Access Compliance Report

Public Rights-of-Way

Intersection ID: 45761	Main Street: SOLACE_CT	Cross Street: GRANDEUR_RD	Location: SE
ADA ID: 2DBD3A28DEA2	Ramp Type: PerpDiag	Initial Pass/Fail: Fail	Overall Compliance: No
		Severity Score: 21.25

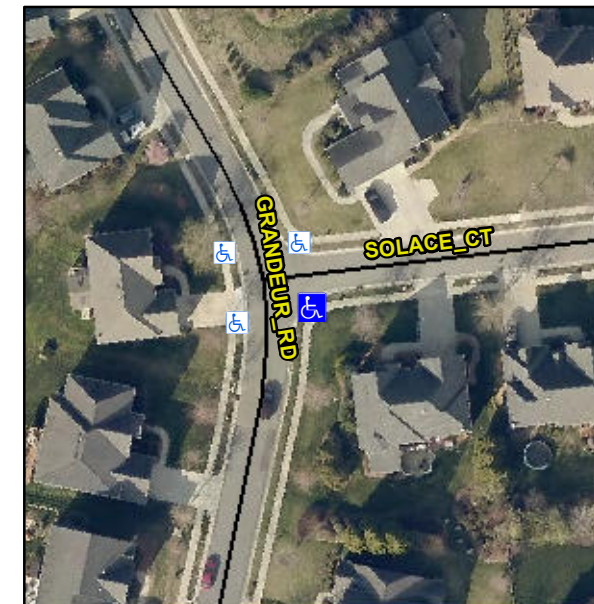
Not Found, R304.5.1, R304.2.2

Compliance	Description	Data	Compliance	Description	Data
N/A	Ramp Length (in)	48.0	No	Ramp Slope (%)	11.7
No	Ramp Width (in)	47.0	Yes	Ramp XSlope (%)	0.9
N/A	Flare Type LT	N/A	N/A	Flare Type RT	N/A
N/A	Flare Slope LT (%)	N/A	N/A	Flare Slope RT (%)	N/A
N/A	Flare Traversable LT?	N/A	N/A	Flare Traversable RT?	N/A
N/A	Landing Length (in)	N/A	N/A	DWS Provided?	N/A
N/A	Landing Width (in)	N/A	N/A	DWS Contrast?	N/A
N/A	Landing Slope (%)	N/A	N/A	DWS Length (in)	N/A
N/A	Landing X Slope (%)	N/A	N/A	DWS Full Width?	N/A
N/A	Landing Curb? (Y/N)	N/A	N/A	DWS Offset (in)	N/A
N/A	Shared Landing?	N/A			
N/A	Gutter Ponding?	N/A	N/A	Gutter Slope (%)	N/A
N/A	Gutter Lip Ht (in)	N/A	N/A	Gutter X Slope (%)	N/A
N/A	Painted X Walk1?	No	N/A	Painted X Walk2?	No
	X Walk 1 Direction	To N		X Walk 2 Direction	To W
N/A	X Walk 1 Width (in)	N/A	N/A	X Walk 2 Width (in)	N/A
	X Walk 1 Slope (%)	1.9		X Walk 2 Slope (%)	1.2
	X Walk 1 X Slope (%)	0.4		X Walk 2 X Slope (%)	3.1

Remove & Replace Curb Ramp With Two New Directional Ramps or Equivalent.
